U.S. NUCLEAR REGULATORY COMMISSION

Report No. 50-305/84-14(DRSS)

Facility Name: Kewaunee Nuclear Power Plant

Inspection Conducted on September 23-28, 1984 (Report No. 50-305/84-14(DRSS))

Attachment: Individuals Contacted
Figures 1 & 2: System Block Diagram
for Honeywell Computer

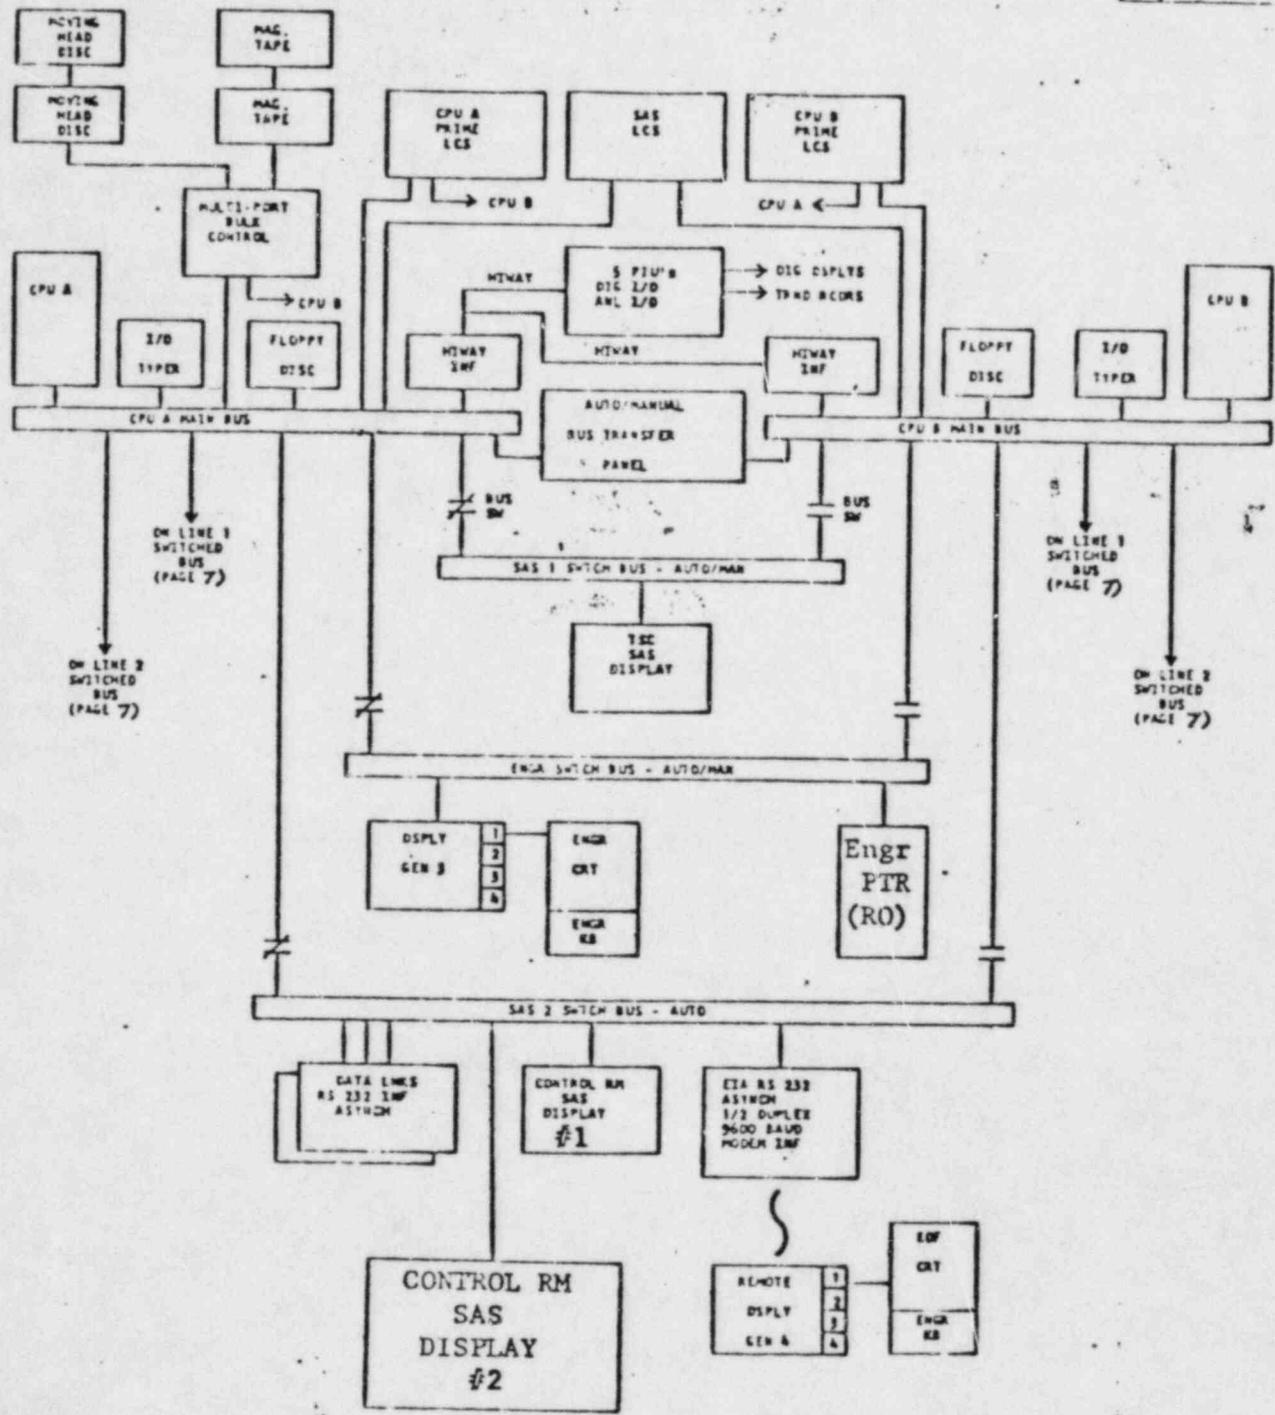
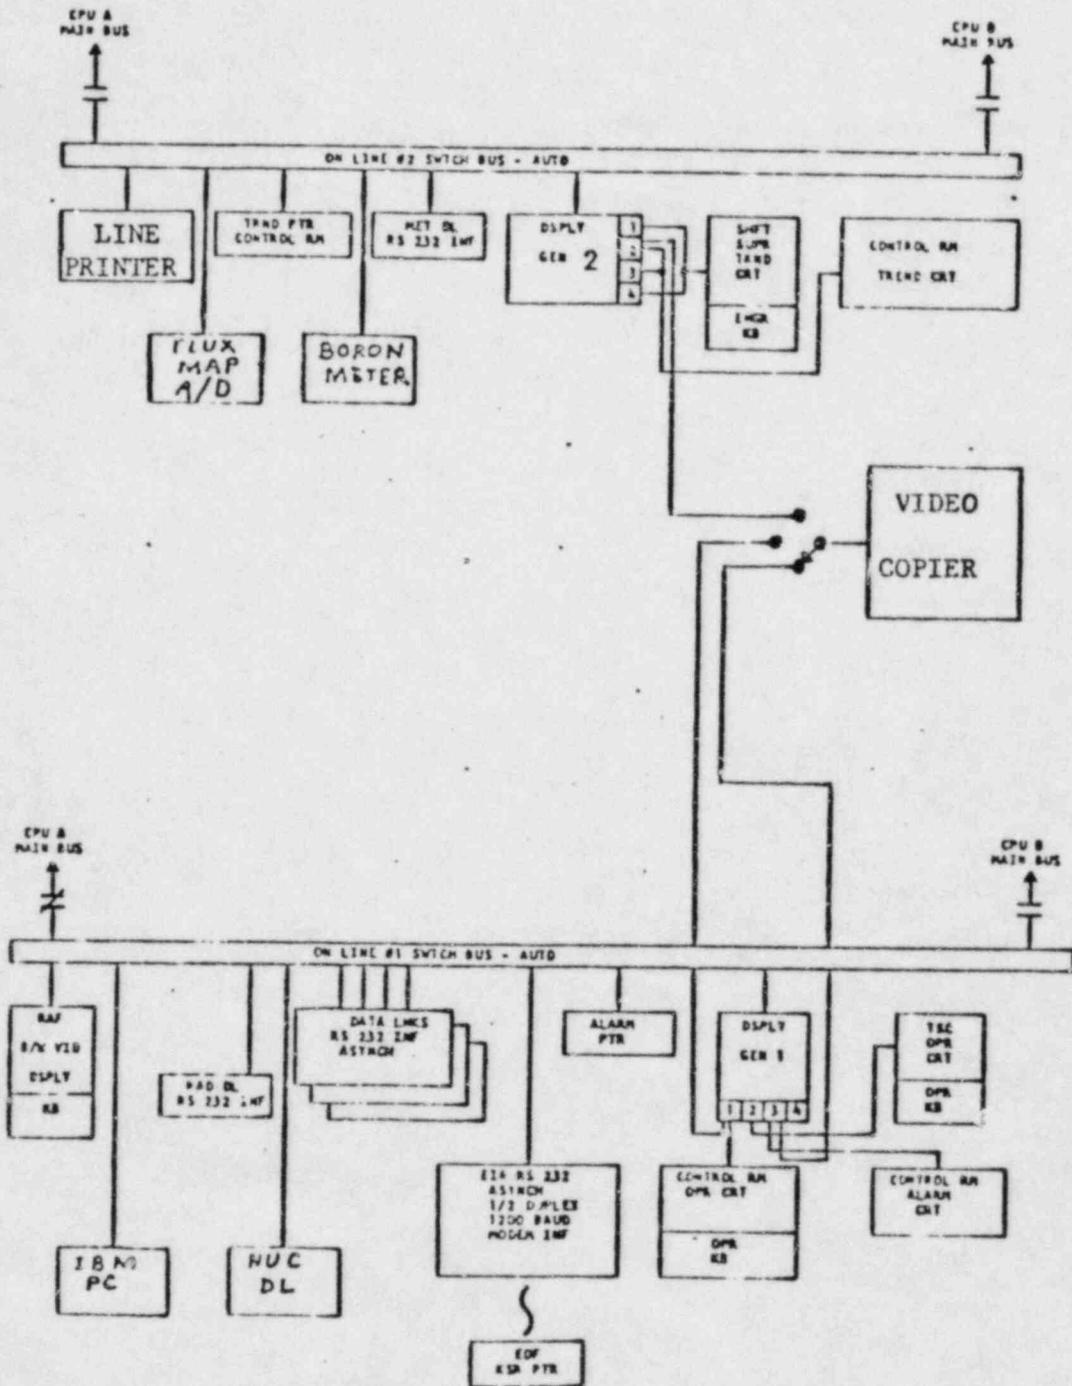
Data acquisition is performed by a redundant Honeywell 4500 computer system and a Honeywell SFER 2200E data acquisition/data base software package. Figures 1 and 2 are block diagrams of the Honeywell 4500 system and peripherals.

The Honeywell computer system has demonstrated the capability to acquire data from sensors sufficient to meet Reg. Guide 1.97 requirements. The Honeywell system can monitor an additional 80 analog and 323 digital sensors. For additional system expansion costs the Honeywell 4500 can collect data from additional sensors.

The Honeywell system should be able to communicate with at least 10 channels without significant response degradation. Additional channel control boards could be acquired if needed to expand communication capability. Peak load and/or accident conditions are not expected to be restricted or degraded with the current input/output channel configuration.

This error checking technique does assure transmission error detection; however, communication line random noise could be interpreted as valid data or commands by the Honeywell 4500. Significant line noise for distances of 50 to 300 ft using coaxial cable for the Control Room and the TSC display terminals is unlikely. Line noise interpreted by the Honeywell 4500 from the TSC and Control Room terminals would in most cases be treated as invalid commands.

Data transmission is adequate between the TSC, the Control Room, and the EOF. The transmission between the Honeywell 4500 and the EOF depends on two serial RS232C phone lines. Should both lines fail, the Honeywell 4500 would be unable to communicate with the EOF and information could only be obtained manually by telephone or radio communications.

- Acquire a 1200-baud dial-up modem for backup emergency data acquisition at the EOF.

- The feasibility of continuous data backup by either addition of another disk or routine storage of sampling data to magnetic tape should be reviewed.
- Two functions should be added to the software capability to improve trending presentation; namely,
 - (1) provide software to plot historical data on the display terminals
 - (2) acquire industry standard graphics devices to allow hard copy graphical output (e.g., Tektronix, Calcomp, Versatek, etc.)
